# 1963 - 1967 Corvette: Service Bulletin: Fuel Gauge System Diagnosis

**Subject:** Fuel Gauge System Diagnosis

**Source:** Chevrolet Technical Service Bulletin

**Bulletin Number:** DR #752, Section VIII

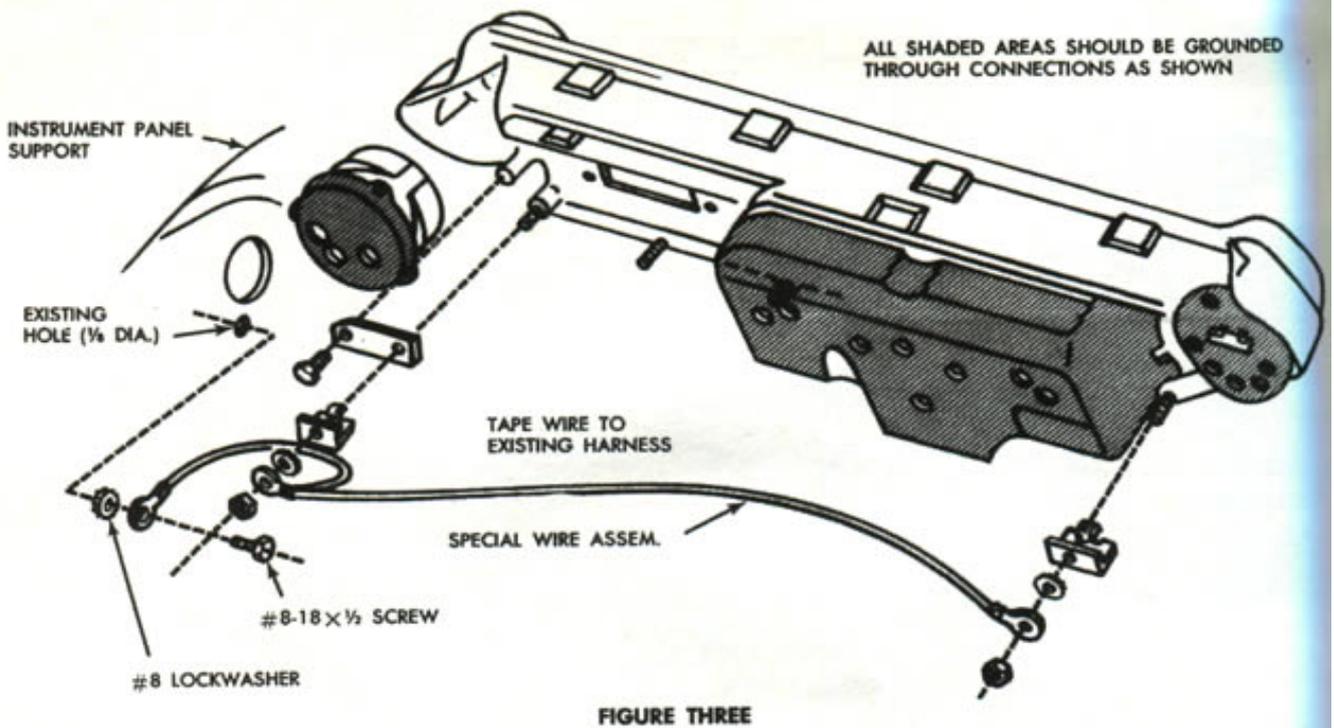
**CAUTION:** In the above procedure, there is a possibility of breaking the solder joint where the suction tube passes through the mounting plate. If this occurs, or if a new tank sending unit is installed on tanks without the orange paint identification, the replacement sending unit should be reworked per Figure 1 (Page 6) prior to installation.

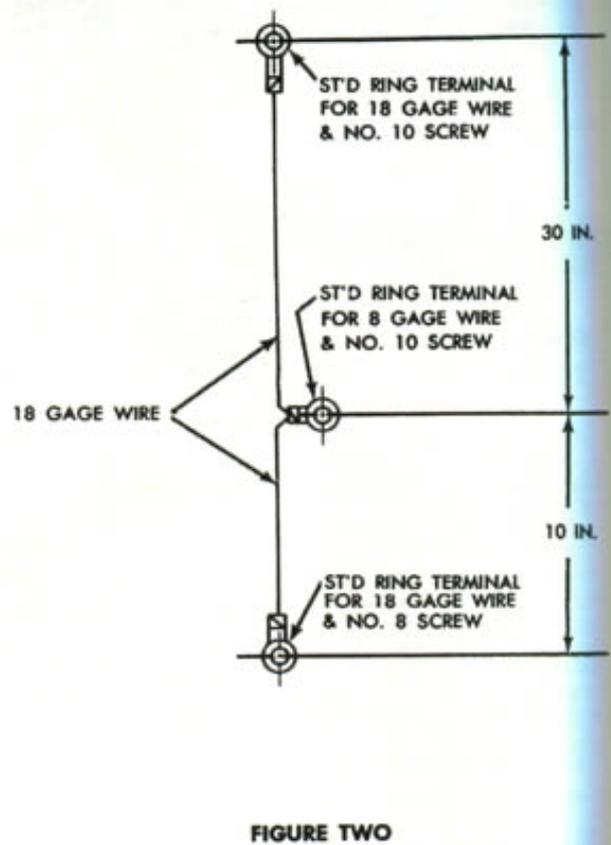
If ground circuit correction is needed, make a ground wire assembly as shown in Figure 2, Page 6. Install as shown in Figure 3, Page 6.
